**JOINT REGIONAL PLANNING PANEL  
(Sydney East Region)**

<b>JRPP No</b>	<b>2011SYE035</b>
<b>DA Number</b>	<b>DA/182/2011</b>
<b>Local Government Area</b>	<b>Randwick City Council</b>
<b>Proposed Development</b>	<b>DA/1113/2010 – Demolition of existing structures on the site and construction of a new part 3 part 7 storey level mixed use development comprising of 3 separate multi-unit buildings to create 103 apartments with basement carparking for 92 vehicles, landscaping and associated works at 2-6 Goodwood Street, Kensington.</b>
<b>Street Address</b>	<b>2-6 Goodwood Street, KENSINGTON NSW 2033</b>
<b>Applicant/Owner</b>	<b>Fox Johnston Architects/ Kensington RSL Sub Branch</b>
<b>Number of Submissions</b>	<b>111</b>
<b>Recommendation</b>	<b>Refusal</b>
<b>Report by</b>	<b>Wendy Wang, Environmental Planning Officer</b>

Figure 5 – overshadowing (shaded red) from a DCP compliant development on the subject site (not shown).

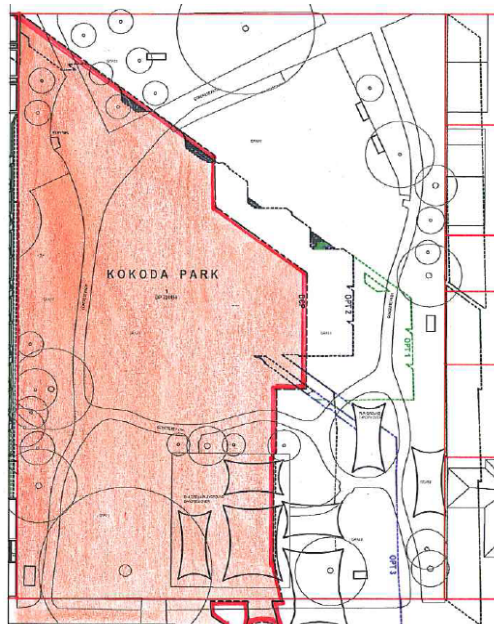
- The proposal adopts narrow building footprints to provide for a greater level of amenity (in terms of landscape provision and ventilation) in order to mitigate negative impacts generated by the development. The applicant has argued that the additional height beyond the height control of 5 storeys and 17.1m (as contained in the RLEP 1998) is a result of the design of the development which seeks to provide increased levels of landscaping through provision of narrower building footprints. The applicant has further argued that the increased amount of landscaping results in higher levels of amenity for surrounding residents. This is not considered to be a valid justification given that the measures only serve to mitigate adverse impacts which result directly from the proposal's degree of non-compliance with Council's planning controls. It is considered that a reduction in GFA, height and scale is considered to be the most rational and effective approach to alleviating the adverse impacts to the amenity enjoyed by surrounding sites and Kokoda Park users.

Figure 7 – Proposed layout and setbacks in relation to the site boundaries (shown in red).

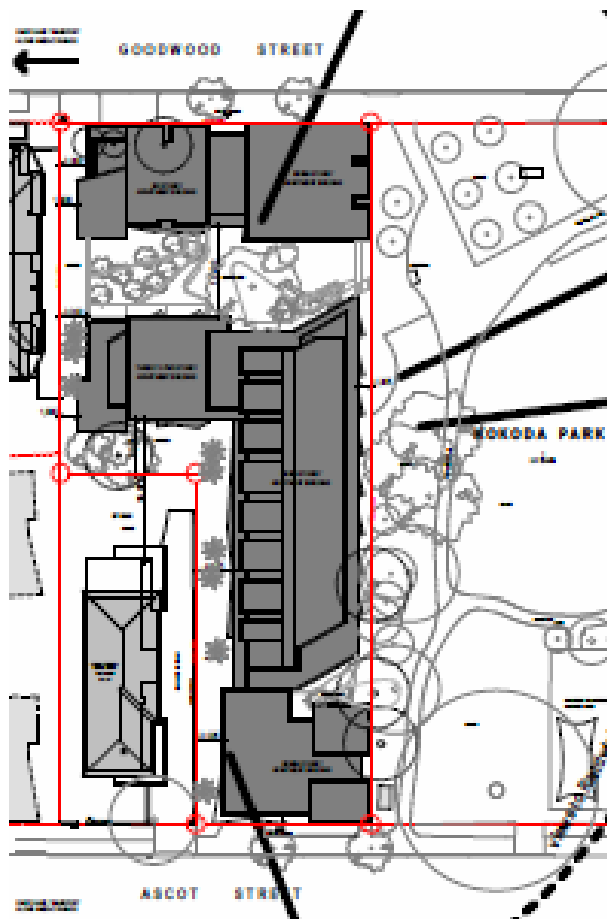
The proposal does not comply with the requirements for transitional development setbacks. A visual and numerical comparison is made below:-

Rear and side setbacks create the relationships between neighbouring buildings, create opportunities for landscaped open space and are important contributors to visual and acoustic privacy. Importantly, in the context of the site's proximity to Kokoda Park, upper levels should be set back to soften the built form, and assist buildings to achieve a human scale. The proposed development, with its excessive height and scale, combined with lack of setbacks at the upper floors is considered to be visually dominating and overbearing. As indicated in the table below, the proposal does not achieve satisfactory setbacks from the streets or adjoining residential flat buildings. This arrangement compromises the solar access, privacy and amenity of the adjoining Kokoda Park and the existing development to the west at Nos. 5 – 7 Ascot Street and 8-10 Goodwood Street.

Figure 9 - The eastern elevation of the building showing an additional 2 and 3 storeys above the DCP's limit distributed along the entire eastern elevation with no visual relief.

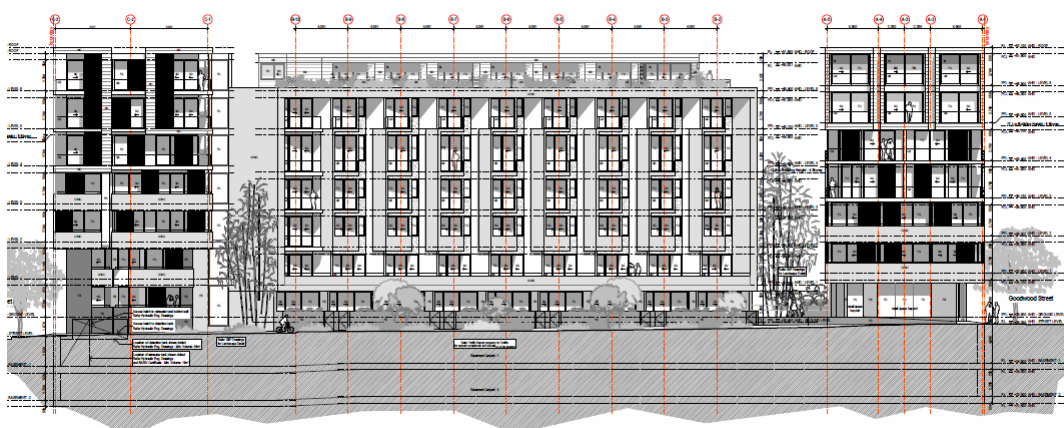
The excessive GFA and resultant height and number of storeys proposed erodes the benefits of distributing floor space over three (3) separate blocks and will result in significant adverse impacts to the adjoining development and Kokoda Park. As such, the development does not meet the relevant envelope controls for Block 02 clause.
